Safety Advisory – Mandatory Upgrade

Upgrade Instructions – For ONLY these FTVN/EFTU model & serial numbers:

Upgrade Kit (No. 6501575600) contents:

STEP 1 — Inspect Condensate Dish

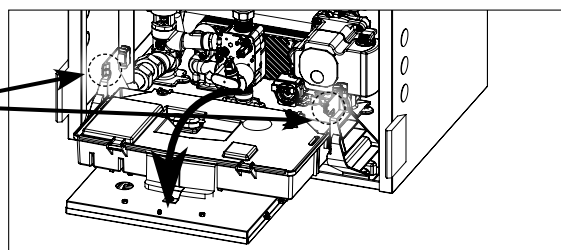
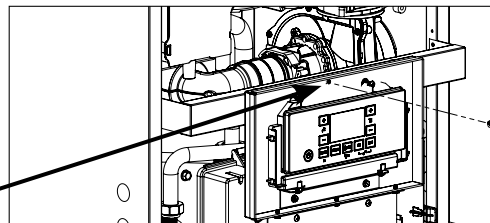
- 1** Remove Front Panel (4 latches)
- 2** Remove Screw (1 x slotted / ¼" hex)
- 3** Push tabs out and pull control panel housing forward

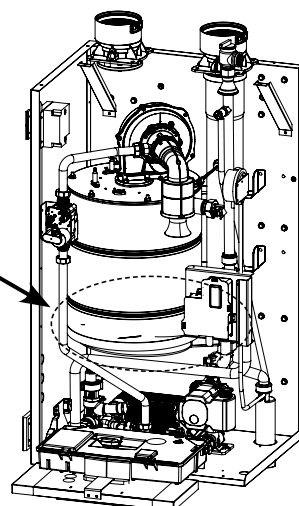
- 4** Check the external surfaces of the condensate dish for signs of damage: cracks, chips, misshapen sections, etc. If the dish appears compromised in any way, STOP using the boiler and contact Ariston Canada immediately to arrange for a replacement (at no charge).

STEP 2 — Replace Control

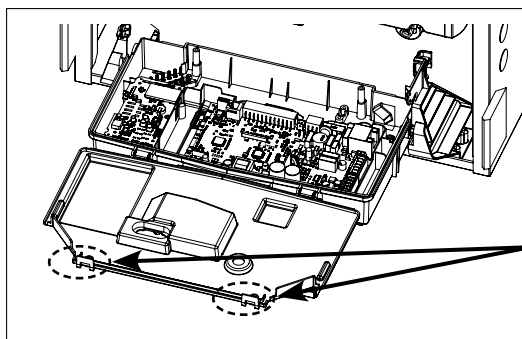
- 1** Unlock the two clips and open the electronics box cover.
- 2** Disconnect harnesses from control (connectors are keyed to prevent misconnection)
- 3** Remove old control (2 tabs); install and connect new control.

STEP 5 — Affix Upgrade Label (supplied in Kit)

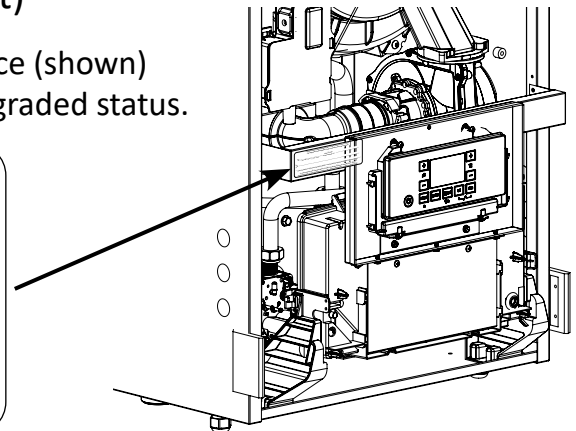
Place the label in a prominent location such as the cross brace (shown) or front cover to advise future technicians of the boiler's upgraded status.
